Errata to MPC8641D Integrated Host Processor Family Reference Manual, Rev. 1

This errata describes corrections to the *MPC8641D Integrated Host Processor Reference Manual*, revision 1. For convenience, the section number and page number of the errata item in the reference manual are provided.

Figure 9-34. Shared Message Signaled Interrupt Index Register (MSIIR)

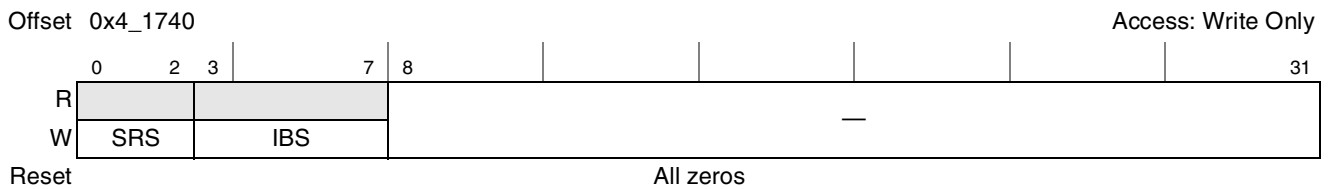
- 9.3.6.3/9-37 In [Figure 9-33](#), “Shared Message Signaled Interrupt Index Register (MSIIR),” changed location of SRS and IBS fields in MSIIR register, as follows. Note that for the MPC8641D Rev 2.0 and earlier, the SRS and IBS fields occupy bits 24–31:

Figure 12-16. Transfer Error Attributes Register (LTEATR)

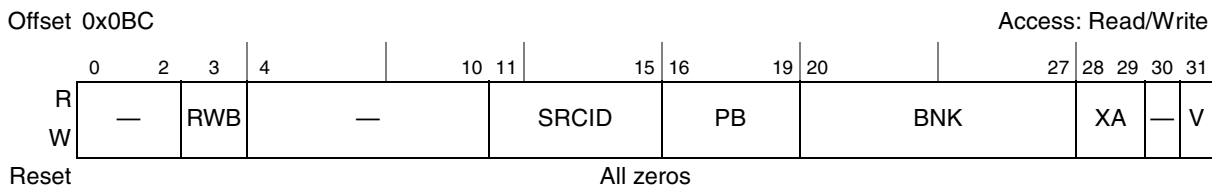
12.3.1.13/12-27 Added Figure 12-16, “Transfer Error Attributes Register (LTEATR),” as follows:

Figure 13-105. RFBPTR0–RFBPTR7 Register Definition

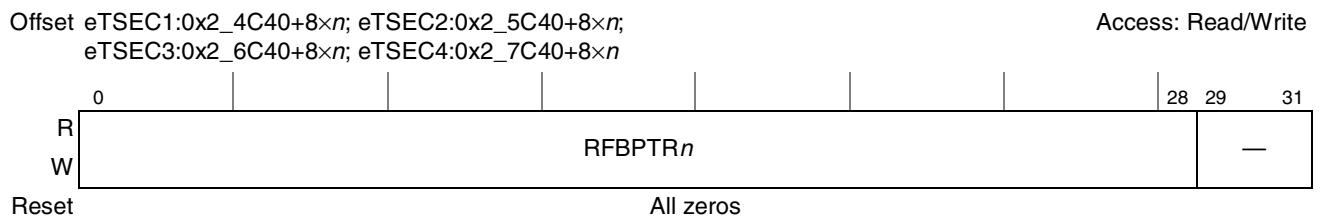
[Figure 13-105](#) describes the definition for the RFBPTR n register.

Bits	Name	Description
0–28	RFBPTR	Pointer to the last free BD in RxB D Ring n . When RBASE n is updated, eTSEC initializes RFBPTR n to the value in the corresponding RBASE n . Software may update this register at any time to inform the eTSEC the location of the last free BD in the ring. Note that the 3 least-significant bits of this register are read only and zero.
29–31	—	Reserved.

Figure 16-30. PCI Express Error Classification

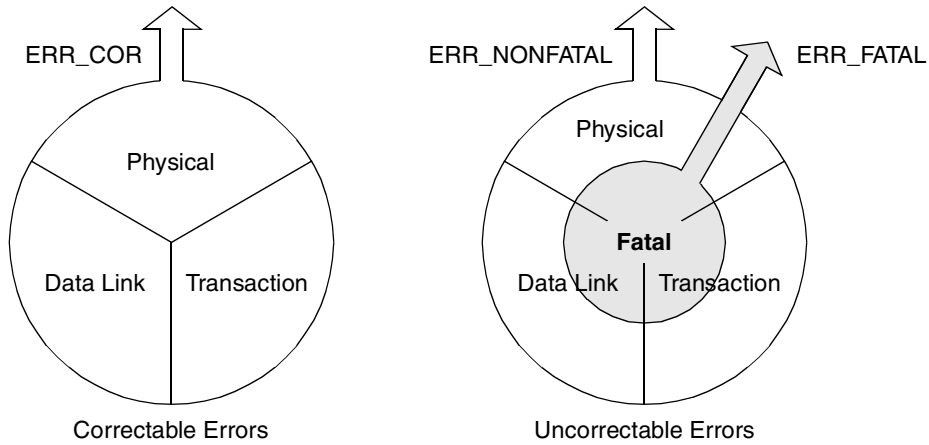
16.4.1.10/16-98 Added [Section 16.4.1.10, “Error Handling,”](#) as follows:

The PCI Express specification classifies errors as correctable and uncorrectable. Correctable errors result in degraded performance, but uncorrectable errors generally result in functional failures. As shown in [Figure 16-130](#) uncorrectable errors can further be classified as fatal or non-fatal.

Figure 16-131. PCI Express Device Error Signaling Flowchart

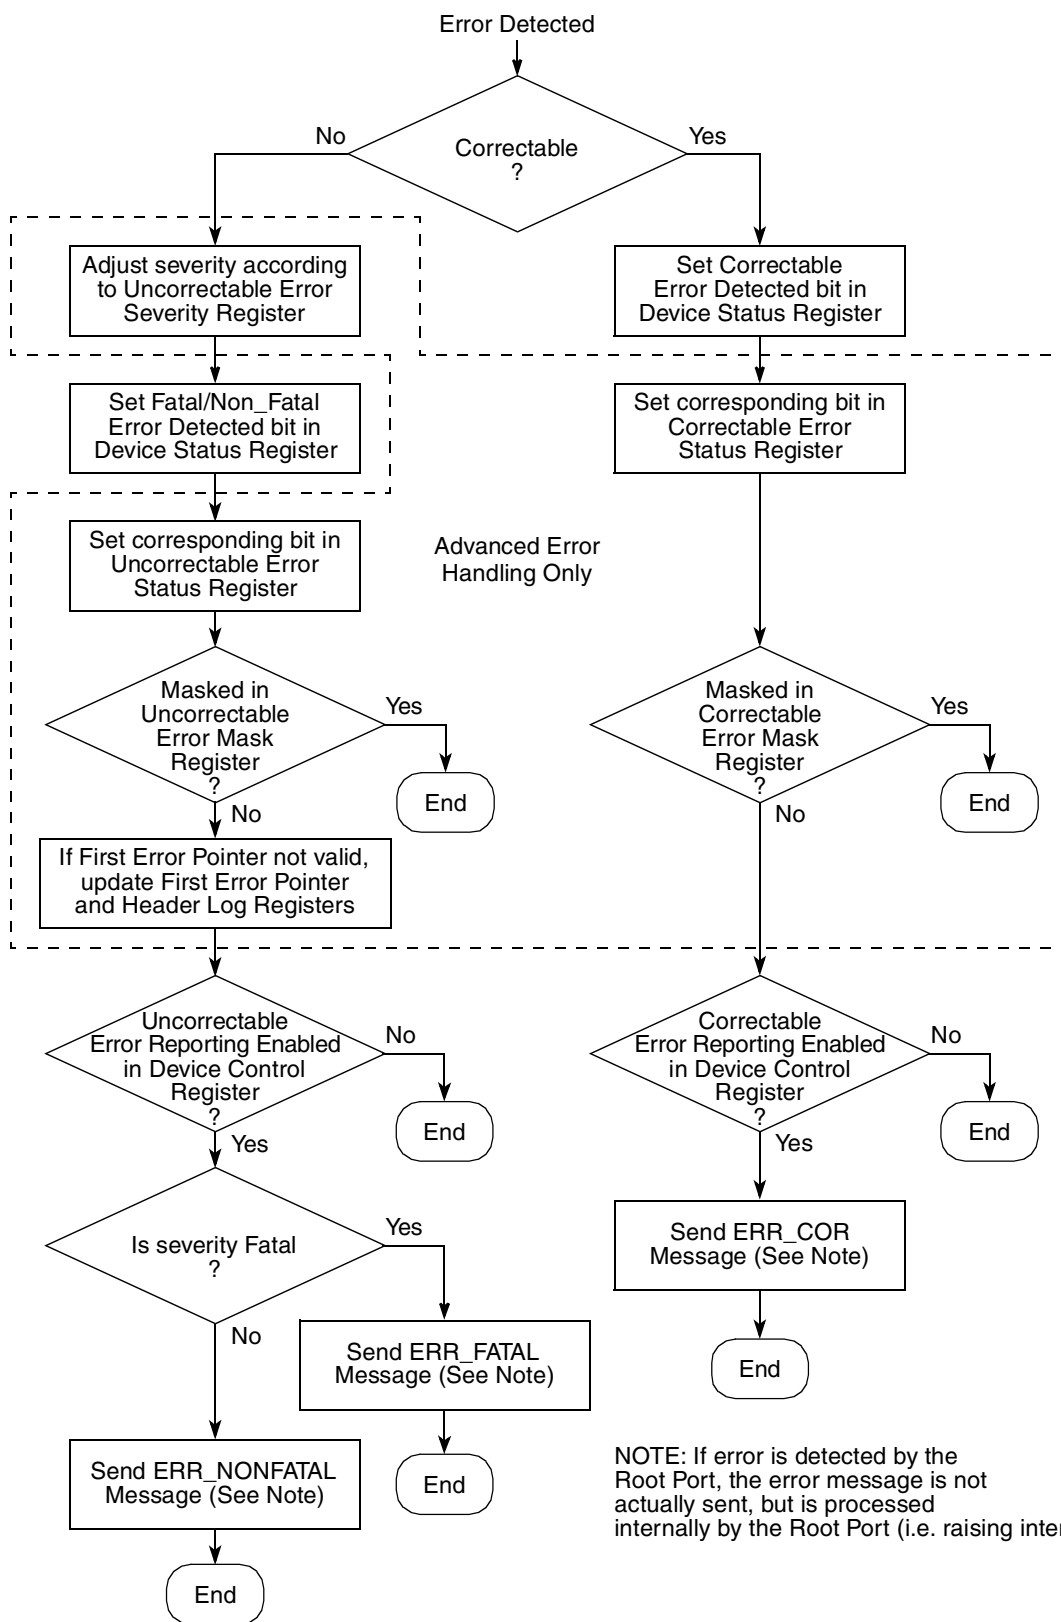
[Figure 16-131](#) shows the PCI Express-defined sequence of operations related to signaling and logging of errors detected by a device. Note that the PCI Express controller on this device supports the advanced error handling capabilities shown within the dotted lines.
